# Access Compliance Report

## Public Rights-of-Way

### (Curb Ramps)

Intersection ID: 3909	Main Street: BENTHAVEN_LN	Cross Street: CHIMNEY_RIDGE_TL	Location: NW
ADA ID: DFF8FECA2E67	Ramp Type: Directional1	Initial Pass/Fail: Fail	Overall Compliance: No
			Severity Score: 26.25

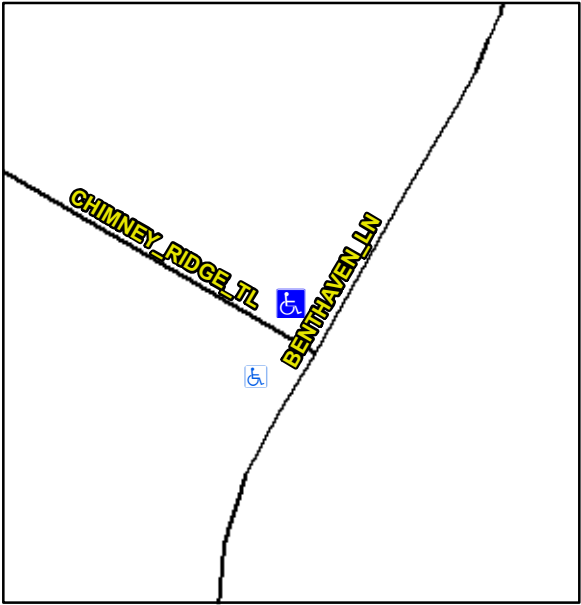
Codes/Mitigation Info/Possible Solution		Field Measurements/Component Compliance																																																																																																																																																							
 <p>Street 1 Name: CHIMNEY RIDGE TL</p> <p>Stop Condition-Street 1: StopSign</p> <p>Street 2 Name: N/A</p> <p>Stop Condition-Street 2: N/A</p>		<p>Possible Solutions:</p> <p><b>Remove &amp; Replace Entire Ramp.</b></p> <p>Surveyor Notes:</p> <p><b>N/A</b></p> <p>PROW/ADA:</p> <p><b>R304.2.2, R304.5.3</b></p>

<table><tr> <th>Compliance</th><th>Description</th><th>Data</th><th>Compliance</th><th>Description</th><th>Data</th></tr><tr> <td>No</td><td>Ramp Slope (%)</td><td>12.9</td><td>N/A</td><td>Grade Break XSlope (%)</td><td>0.0</td></tr><tr> <td>No</td><td>Ramp XSlope (%)</td><td>4.1</td><td></td><td></td><td></td></tr></table>
